1 November 2018

10051

Barangaroo – Block 4 Remediation, Land Forming and Excavation Works (SSD 5897) Modification Application No. 1 (Remove Part of Retaining Wall)

Figure 1 – Approved extent of Block 4 retention wall system

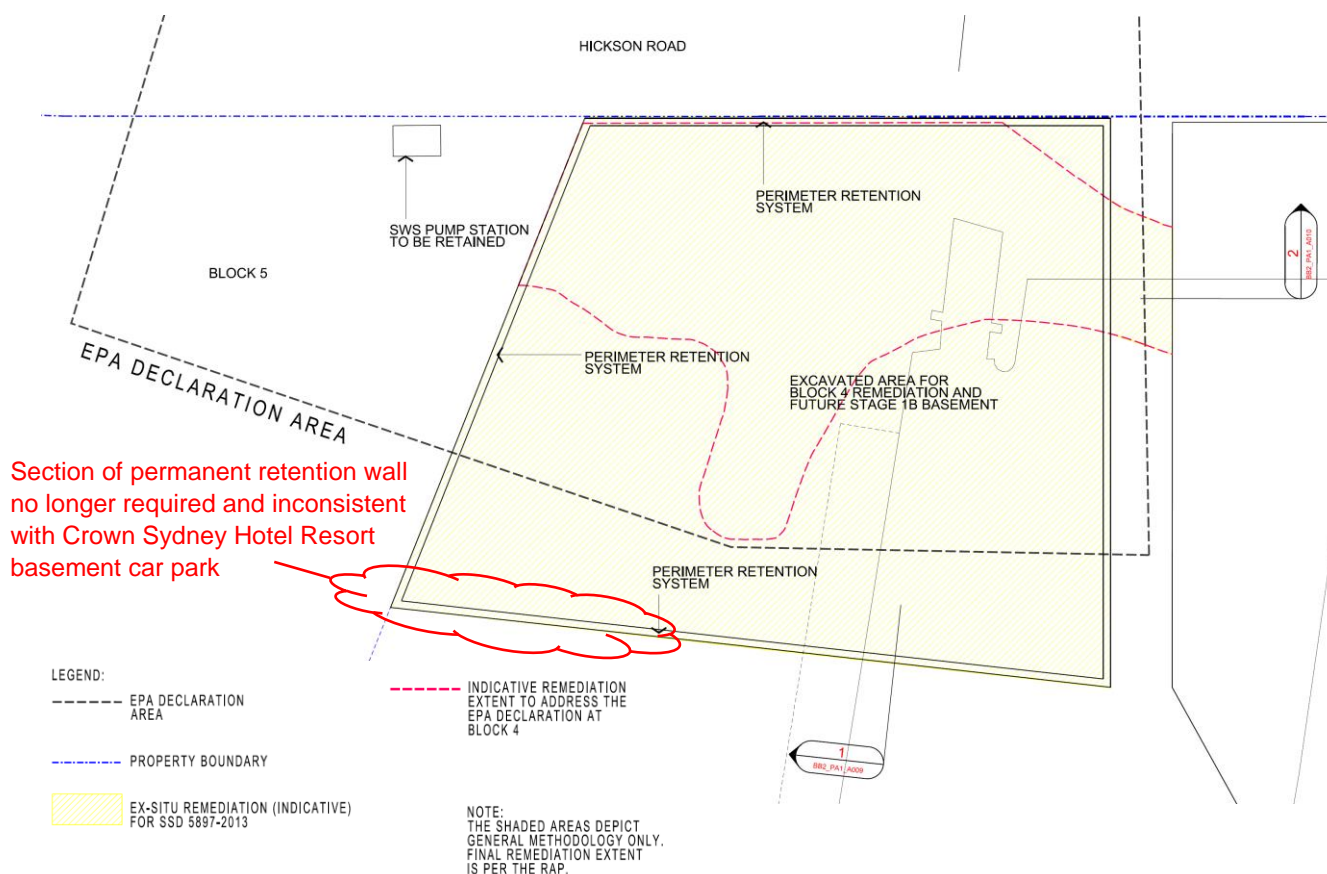
SSD 5897 approved the installation of a permanent retention wall system surrounding Block 4. The Block 4 perimeter retention wall system is facilitating the Block 4 development remediation works as well as the Stage 1B excavation and landforming works. The extent of the Block 4 perimeter retention wall system as approved is shown in **Figure 1** and **Figure 2**.

Figure 3 – Approved extent of Crown Sydney Hotel Resort retention wall system and excavation area (Stage 1C)

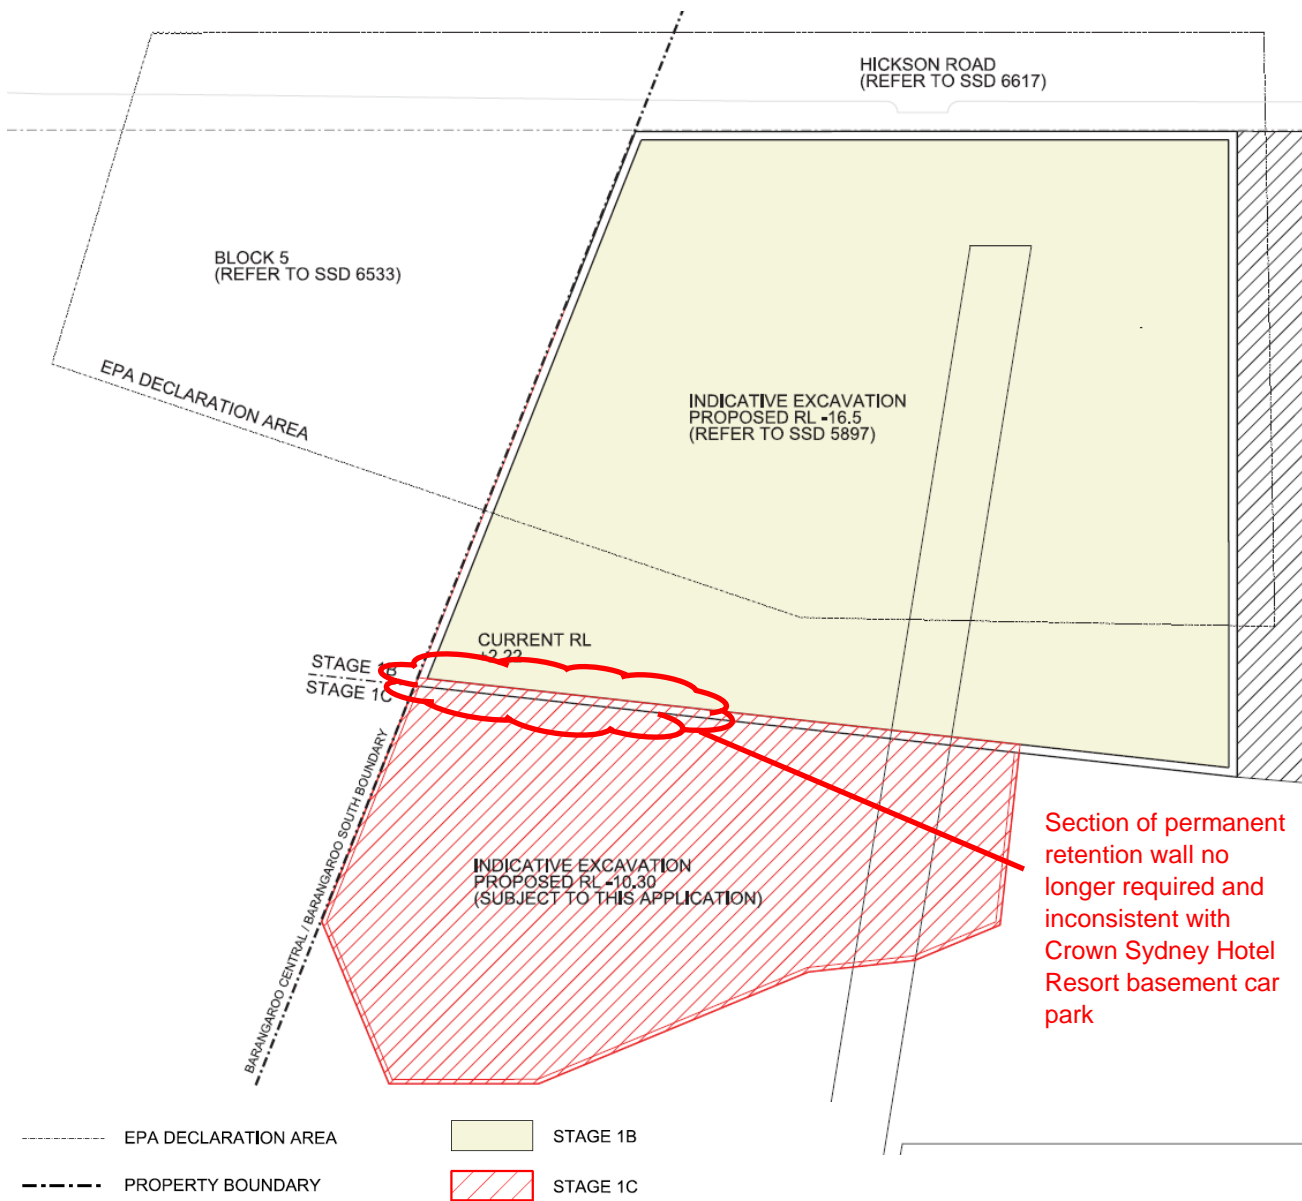
As shown in Figure 3, the Crown Sydney Hotel Resort perimeter retention system relies on part of the Block 4 perimeter wall system along the boundary between Stage 1B and Stage 1C. SSD 6957 therefore obtained approval to construct this part of the Block 4 perimeter retention wall, either as part of the permanent perimeter retention wall system or as a temporary retaining wall to facilitate excavation, if it was not already constructed under SSD 5897.

Figure 8 – Block 4 perimeter retention wall as it is proposed to be modified

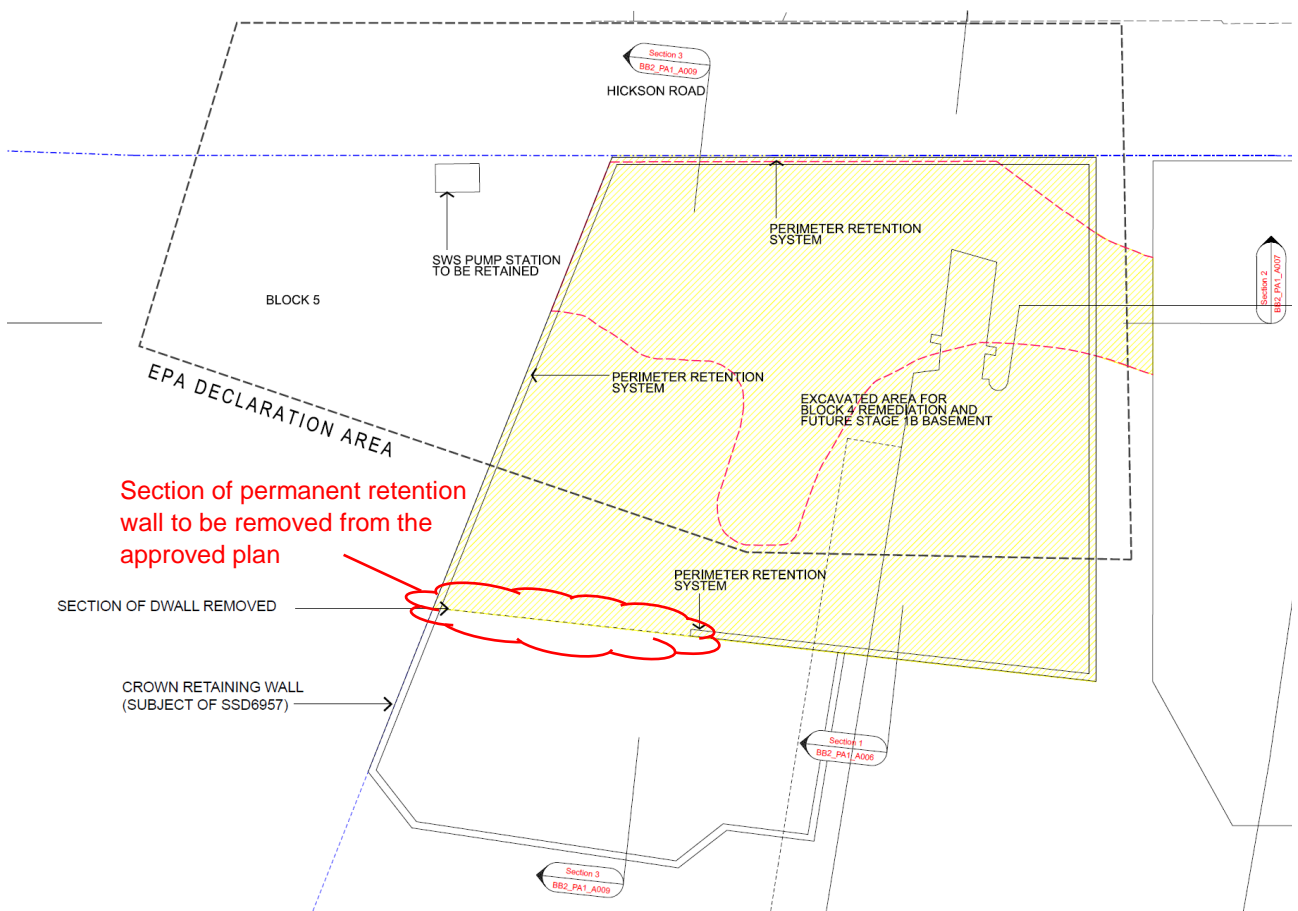
The purpose of the modification application is therefore to modify SSD 5897 to clarify the extent and location Block 4 perimeter retention wall system, in relation to the new Stage 1C boundary and approved Crown Sydney Hotel Resort development. The plan and section showing the extent of the perimeter retention wall as it is proposed to be modified are provided in **Attachment A**, and an extract is provided in **Figures 8 and 9**.
